Access Compliance Report

Public Rights-of-Way

(Pedestrian Signals)

Intersection ID: N/A	Main Street:	Cross Street: N/A	Location: N/A
ADA ID: E705F627CA41	Signal Type: One Push Button-APS	Overall Compliance: No	Severity Score: BTN 1: N/A BTN 2: N/A No BTN: N/A
Codes/Mitigation Info/Possible Solution		Field Measurements/Component Compliance

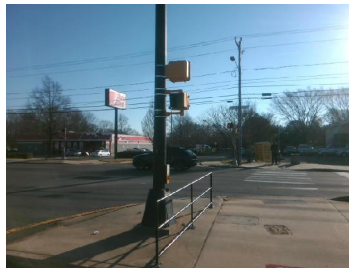
PROW/ADA: TMUTCD 4e.08, R406.2, R404.7.3, R209.1, MUTCD 4e.10

Yes	B 1 Clear Xing Direction?	ClearlyMarked	N/A	B 2 Clear Xing Direction?	N/A
	B 1 Crossing Direction	To SE		B 2 Crossing Direction	N/A
Yes	B 1 DistanceTo XWalk (in)	26.0	N/A	B 2 DistanceTo XWalk (in)	N/A
No	B 1 DistanceTo Curb (in)	108.0	N/A	B 2 DistanceTo Curb (in)	N/A
Yes	B 1 Diameter (in)	2.0	N/A	B 2 Diameter (in)	N/A

Possible Solutions: Replace Signal Push Button With APS Button on New Post. Remove & Relocate Sign.
